## Customer Advisory Notice

**Reference:** PRB-213063

**Subject:** Evolis Medium Voltage up to 17,5kV Circuit Breaker (CB), installed with Undervoltage Release (MN coil), supplied in Australia since January 2005.

Fig. 1

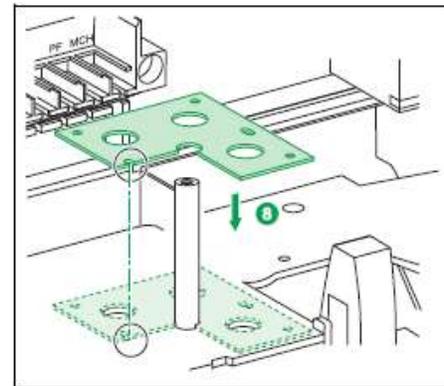
In 2005, a shock absorber vibration pad was introduced to improve resistance to very heavy vibrations and shocks for the Evolis Undervoltage Release (MN coil). To cater for the extra thickness of the vibration pad (refer Fig. 1), a “longer pin” MN coil was also introduced. Refer vibration pad (item 8) in diagram on the right.

Fig. 2 Types of MN coil position

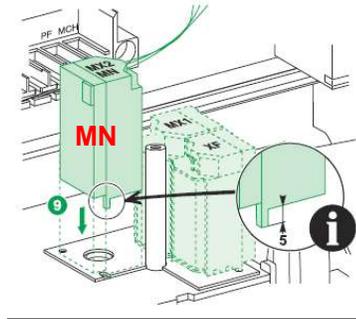
Our technical expert assessment found that the MN coil was out of position and a “3mm short pin” MN coil (e.g. ref. 33670) was installed when a “5mm long pin” MN coil (e.g. ref. 59290) should have been used. Refer to following diagrams.

The “3mm short pin” MN coil with its vibration pad may have been dislodged due to excessive external vibrations or heavy shock. An out of position MN coil may not be able to trip (open) the Circuit Breaker. However, the Circuit Breaker can still be tripped (opened) with the Shunt Trip (MX coil) or via the manual OFF button.

Fig. 12 Location of MN coil and Vibration pad

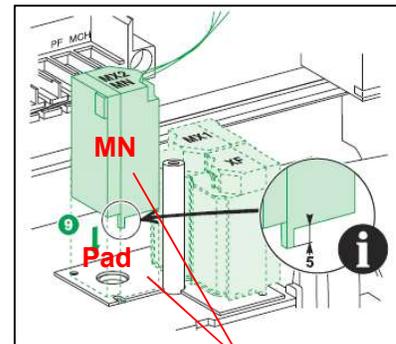
4) If item 3) determined that an MN coil is installed in the CB, remove the front cover (Fig. 10) and locate the MN coil (Fig. 12). Then identify the reference number written on the MN coil. Refer below picture (Fig. 11).

- a. If there is **no** vibration pad fitted, then either “3mm short pin” MN coil references or “5mm long pin” MN coil references can be used.
- b. If there **is** a vibration pad fitted, then **only** “5mm long pin” MN coil references are to be used:

If you identify that a “3mm short pin” MN Coil is fitted with a vibration pad in your Evolis CB, please contact our Customer Care Technical Support Help Desk by e-mail: [techsupport.pz@schneider-electric.com](mailto:techsupport.pz@schneider-electric.com) to request a replacement MN coil by providing the following required information:
